# Village Gardens Development

### Construction Impact Assessment &

### Tree Preservation Plan

Date of Issuance: June 12, 2020  
*Revised:* December 9, 2020  
(changes marked with a red asterisk \*)

Figure 1: Close-up of building extents in relation to elm #37. The red rectangle is an existing paved picnic table area.

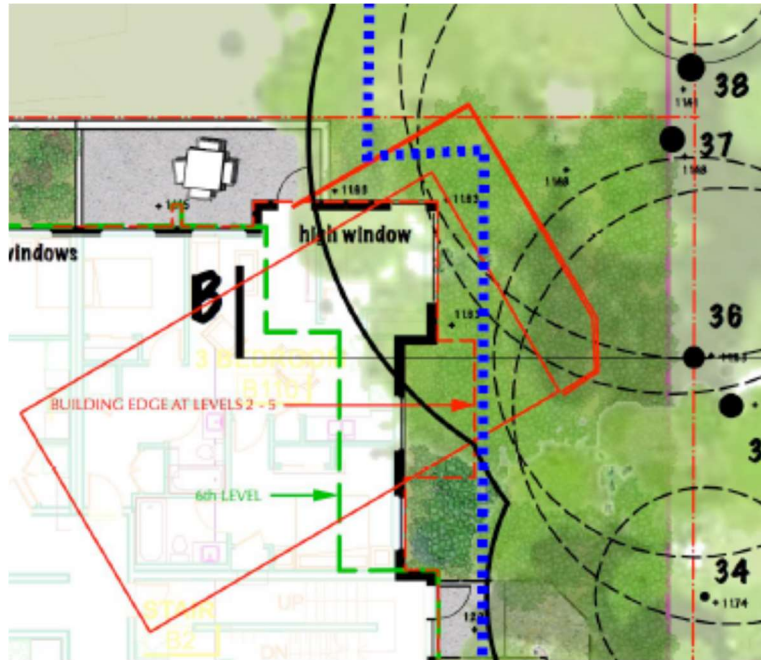
We do not anticipate a significant impact as a result of the foundation or parkade excavations (the parkade is farther away from this tree than the other elms). However, approximately 40-50% of the live canopy of the tree will require removal if 1m of clearance from the building and balconies is desired (see photographs #1 and 2, and Figures #1 and 2 for close-ups of the landscape plan).

A codominant union exists at 6m above ground and the larger stem leans and conflicts with the proposed building façade and to a lesser extent the balconies. The main trunk of the stem will not require removal, but almost all of the horizontal limbs will have to be removed or reduced. Elms will typically sucker rapidly and therefore reducing some limbs to branch stubs may be preferable instead of removal wounds to the trunk (there does not appear to be many suitable laterals to cut back to as almost all of the live growth is at the ends of the limbs).

**\*This pruning will likely result in sucker growth from the pruning wounds and along the length of this stem. If an attempt is made to properly restructure the tree after building clearance pruning, it will likely require ongoing cyclical pruning in the long-term.**

Figure 3: Grading plan for the gravel pathway within the CRZs of retained elms trees.

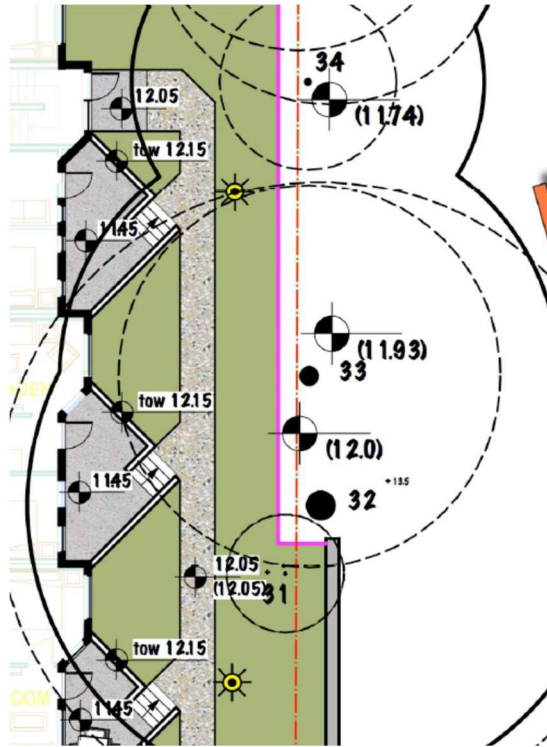
The permeable gravel pathway proposed through the root zones of the elm trees #32-37 (see Figure 3) should be constructed above existing grade in order to avoid root loss. The grading plan shows the plan at the same grade as existing (12.05m); in reality, the gravel may be slightly above existing if surface roots are encountered immediately. Any excavation should be supervised by the project arborist.
